RESPONSES TO HOLD ON 511 N. BROADWAY

172738 | Broadway Connection Engberg Anderson Project No. 172738

RE: Responses to HOLD on 511 N. Broadway form 10/01/2018 HPC meeting.

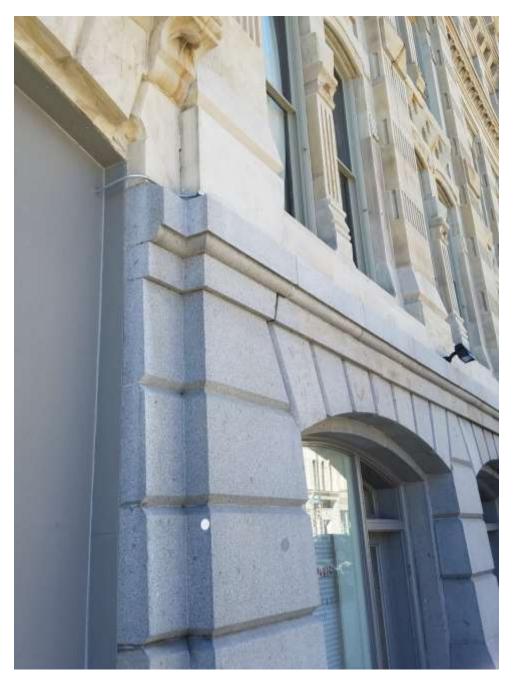
2. Add fenestration to north wall.

- See below for revised north wall elevation that now includes fenestration. See page S-04.
- 3. <u>Refine SE corner to tie in to the design concept together more coherently.</u>
 - See below for exploded axon to help clarify relationships of SE to the overall design concept. See pages S-05 & S-06.
